Title the site plan “Tarahumara Trucking-Site Plan”.

TARAHUMARA SUBDIVISION FILING NO. 1

COVER SHEET	DATE	CAD NO	JOB NO
2260 ANDES WAY AURORA, CO 80011	03/28/23	954-1	954-1

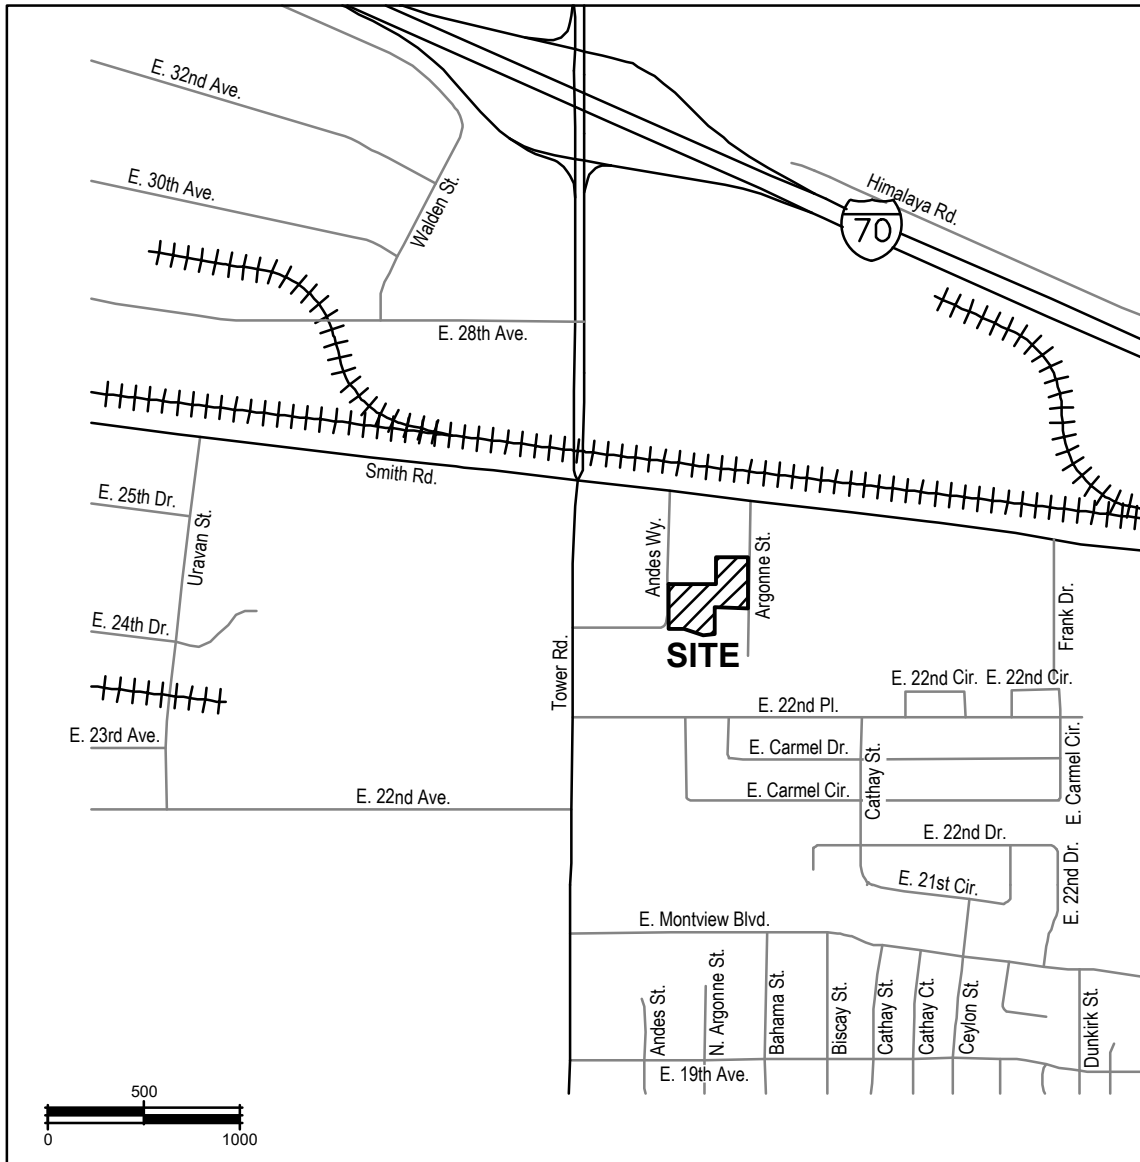
Please delete
crossed out
portion

SHEET NO
2 OF 13

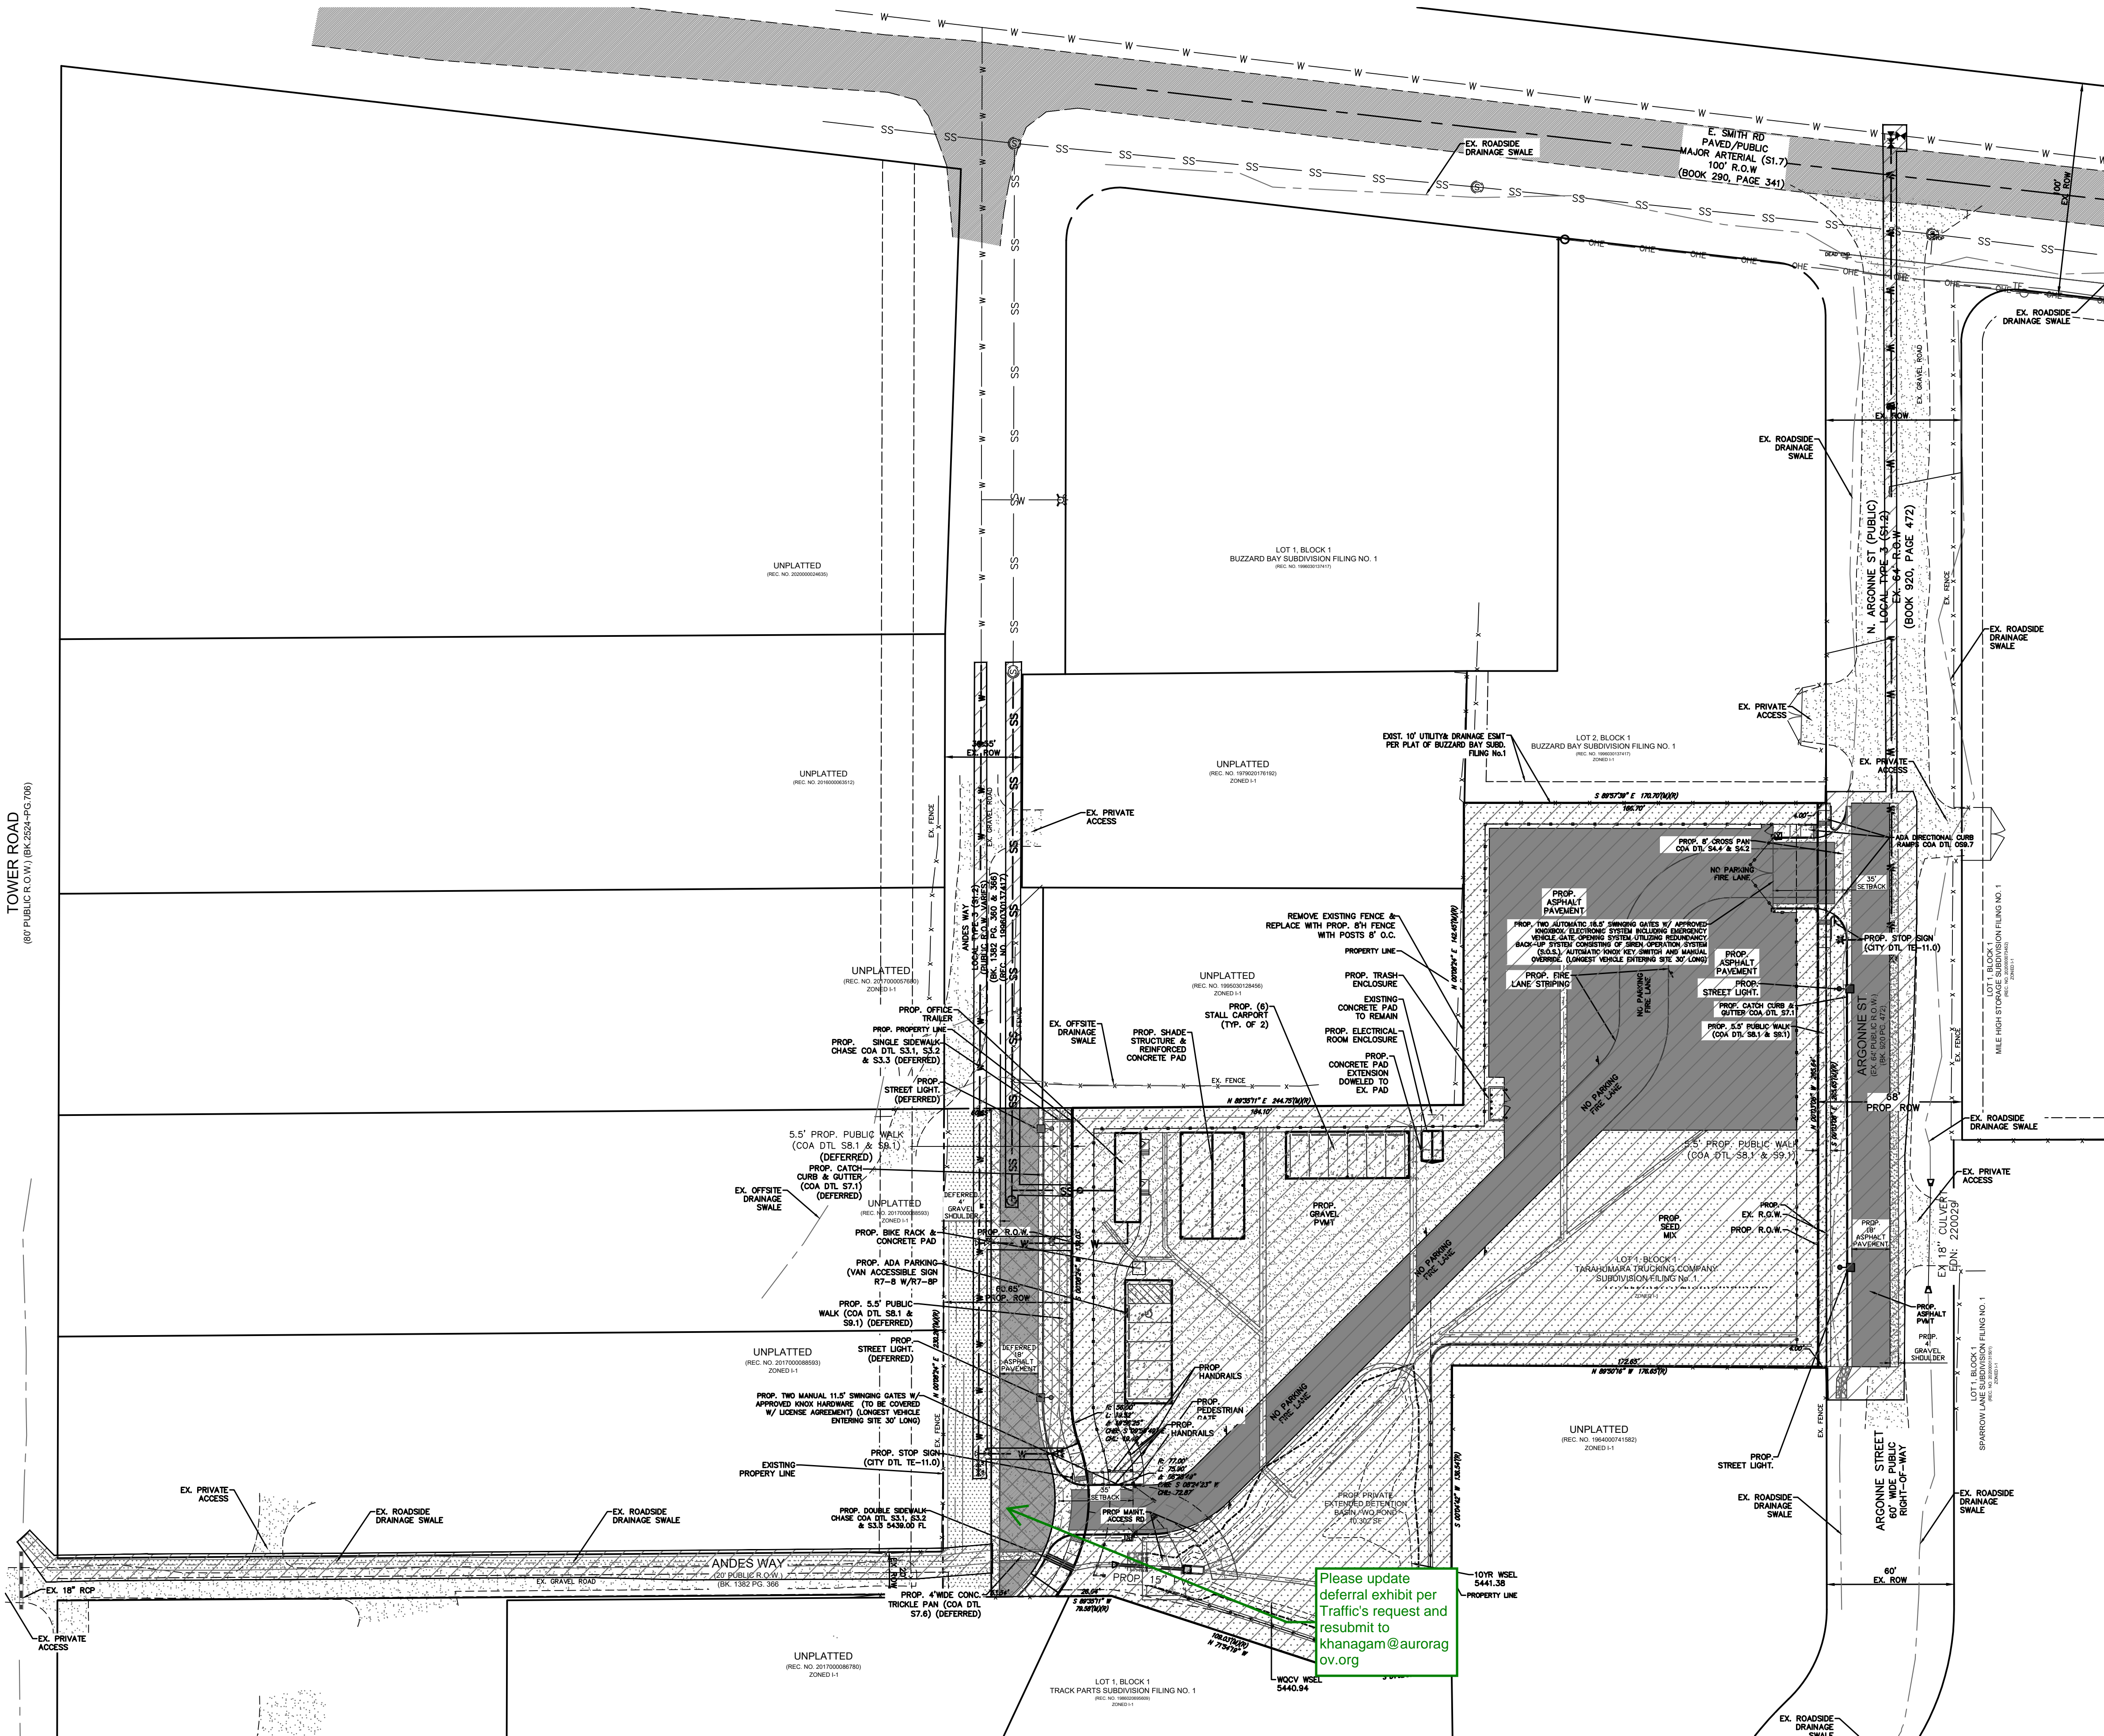
This sentence is a repeat of the previous sentence. Remove but keep the other one.

This access will need to be aligned with access on the other sides of Argonne St. The other choice is to move the access a min of 75' south and be between the two accesses on the east. Access needs to be a minimum of 75' from other accesses for safety.

INTERIM GRADING PLAN
2260 ANDRES WAY
AURORA, CO 80011

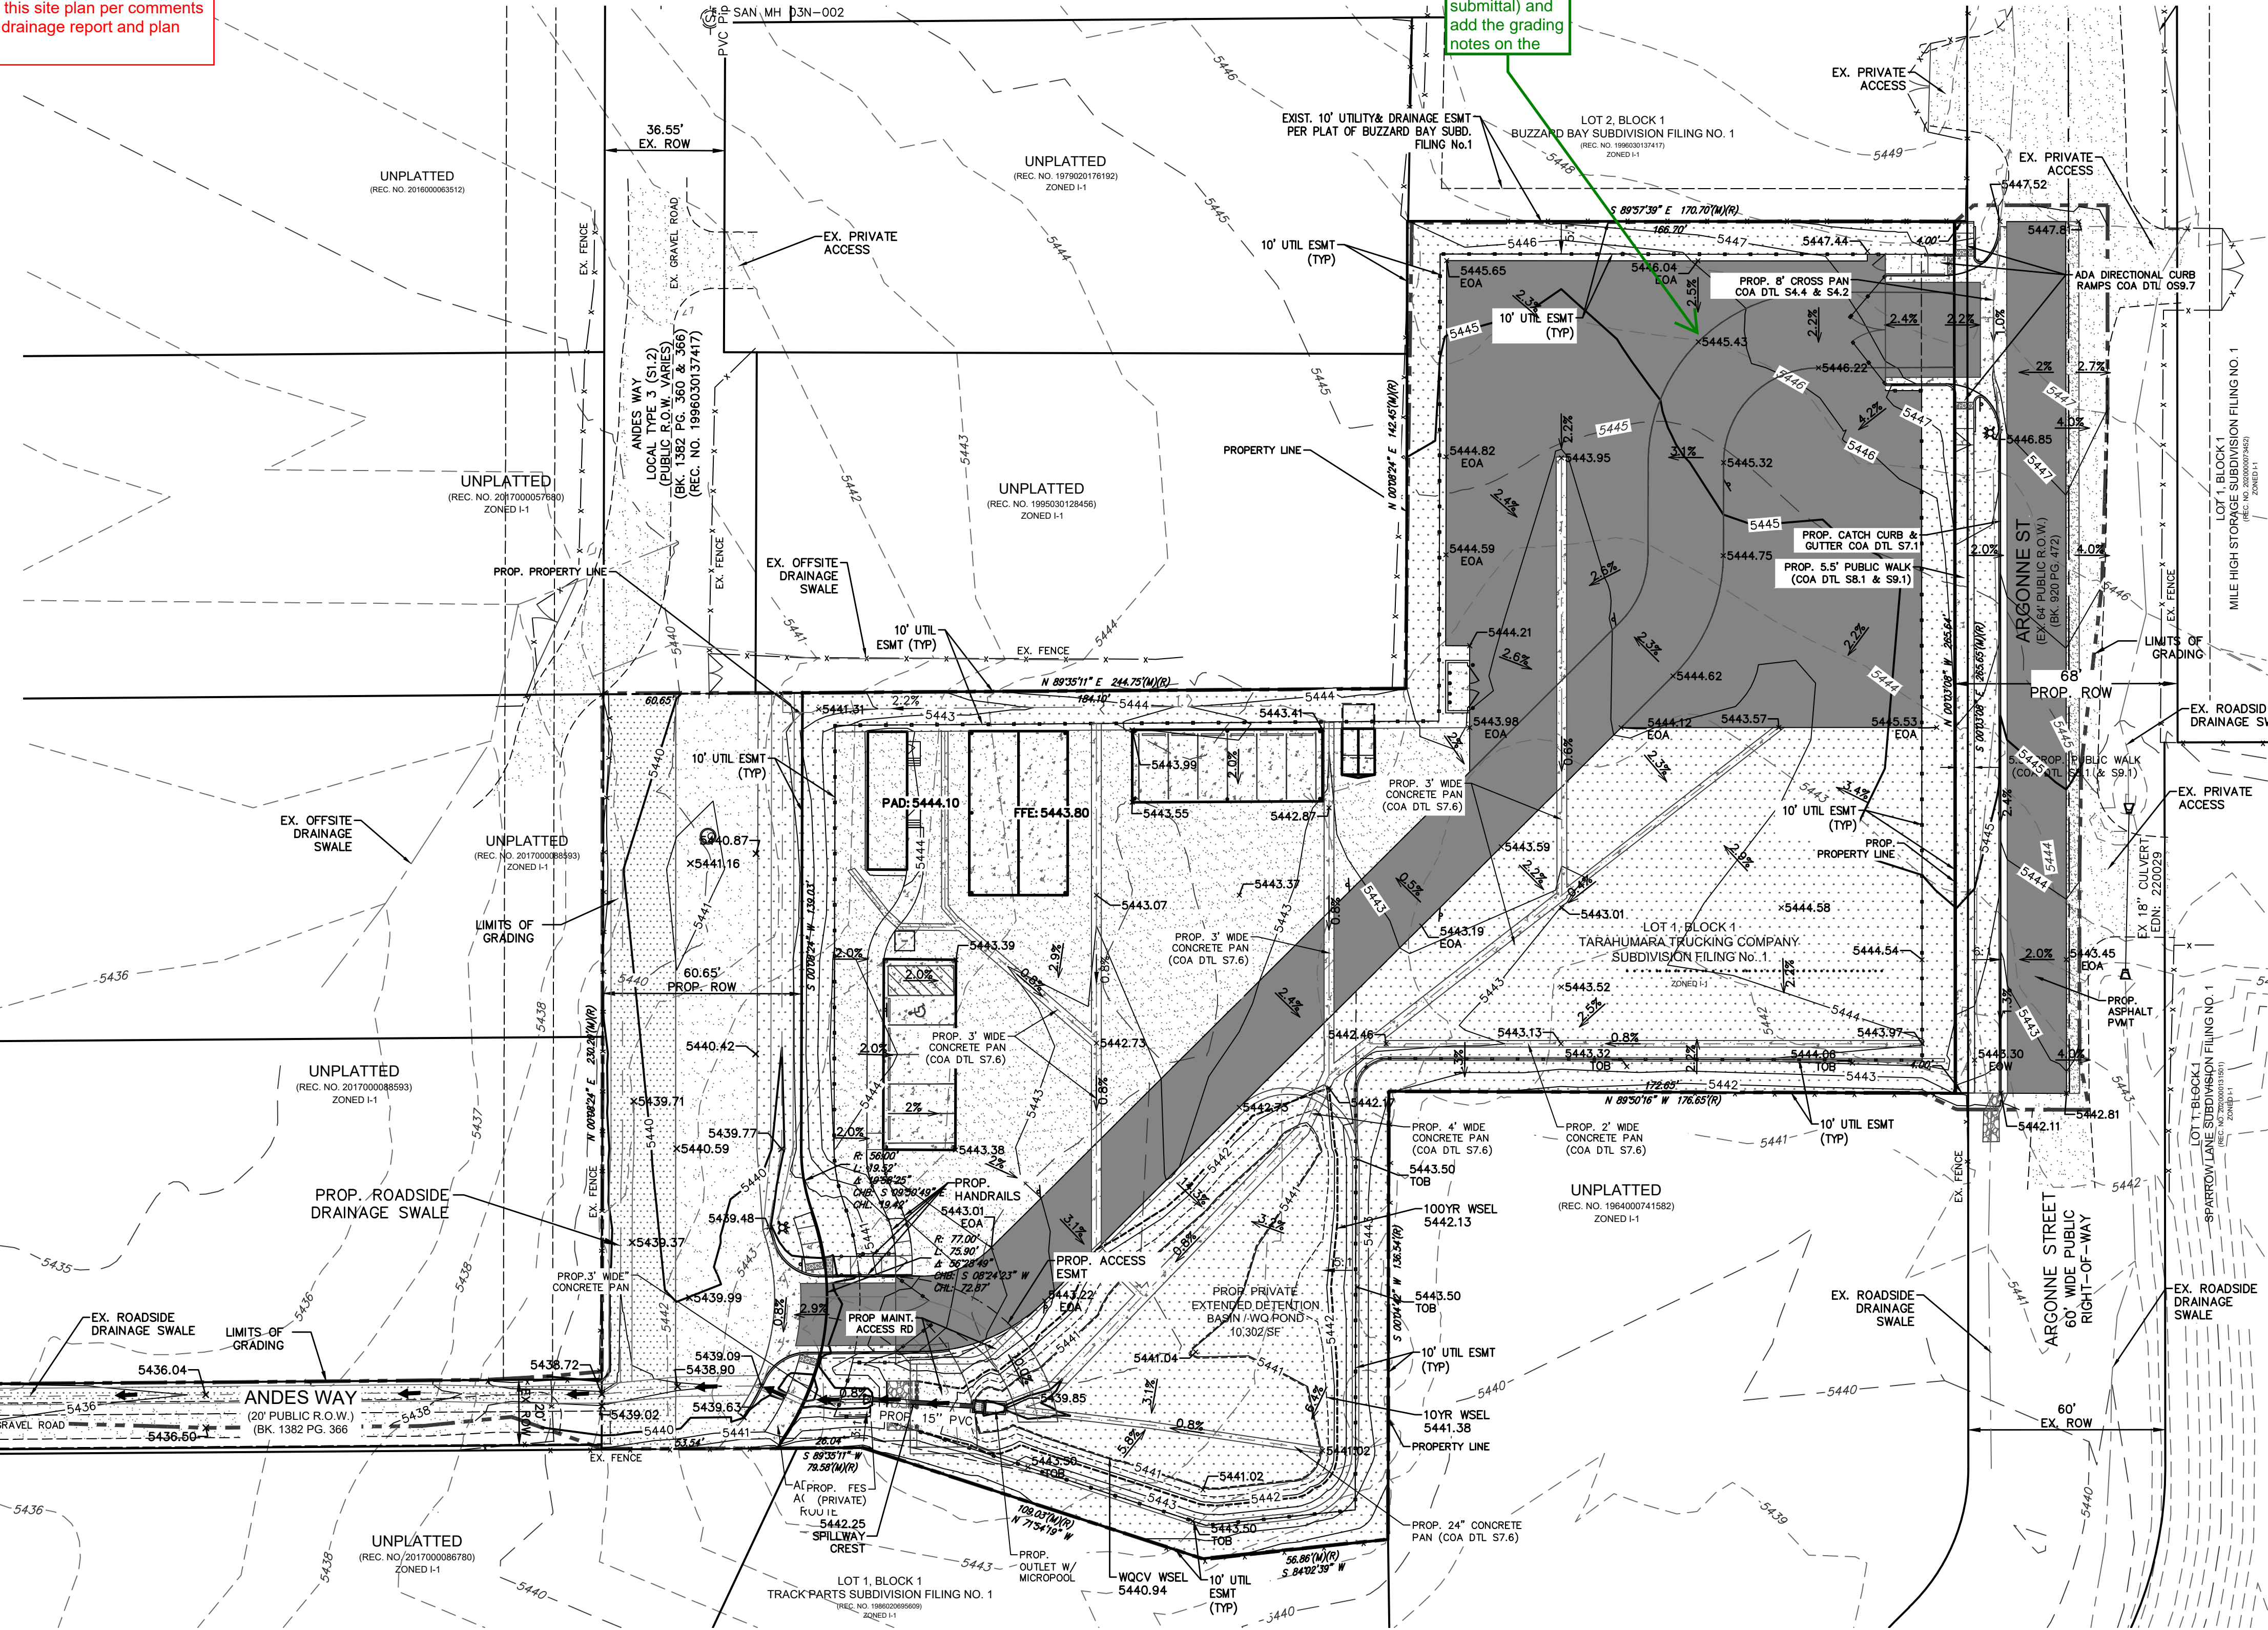
Show revisions on this site plan per comments on the preliminary drainage report and plan (TYP)

- Please add the following notes:
- Minimum slope on unpaved areas is 2%, minimum slope on asphalt is 1%, and minimum slope on concrete is 0.5%.
 - The maximum slope within ROW is 4:1, the maximum slope for property outside of the ROW is 3:1.

- The slope away from the building shall have a minimum grade of five (5) percent for the first ten feet or to the property line, whichever occurs first, then a minimum of two (2) percent until the slope reaches the swale around the building. If physical obstructions or lot lines prohibit the ten feet of horizontal distance, a five (5) percent slope shall be provided to an approved alternative method of diverting storm runoff away from the foundation. Impervious surfaces within ten feet of the building foundation shall be sloped a minimum of two (2) percent away from the building.

- The maximum permissible longitudinal grade for fire lanes is 10%. The maximum transverse grade for a fire lane is four percent with a resultant maximum slope of ten percent.

- The resultant grade in any direction within accessible parking areas shall not exceed two percent.
 - The maximum cross slope in an accessible path shall not exceed two percent. The maximum longitudinal slope along an accessible path shall not exceed five percent.

Please remove spot elevations, typ. (include this level of detail on the civil plan submittal) and add the grading notes on the

(2) 11.5' MANUAL SWING GATES WITH KNOX HARDWARE DETAIL (WEST)

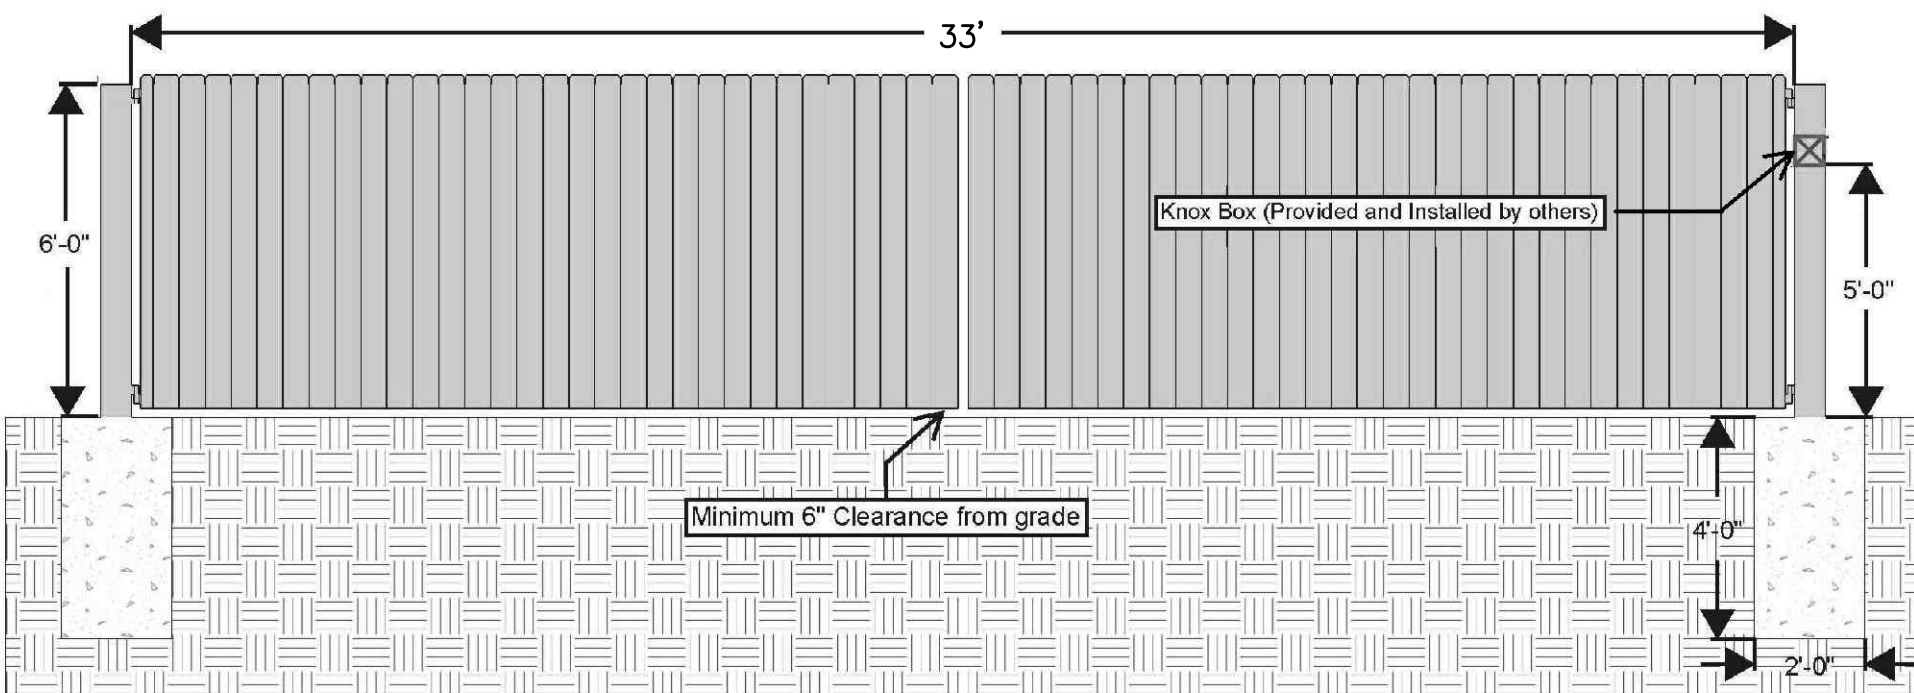
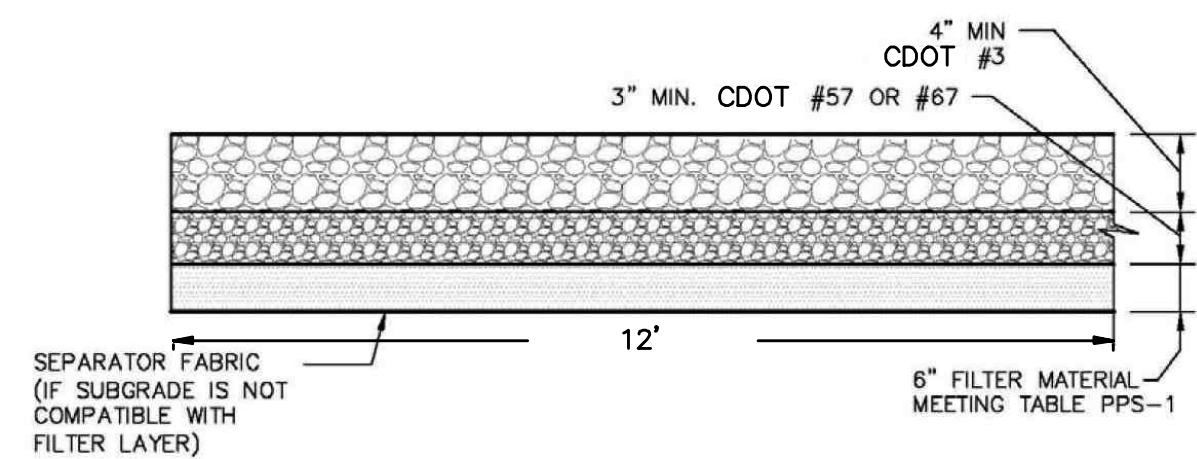
- Provide details for the man gates on the east and west side.
- Provide basic details for the proposed shade structure.
- Provide basic details for the proposed electrical enclosure.
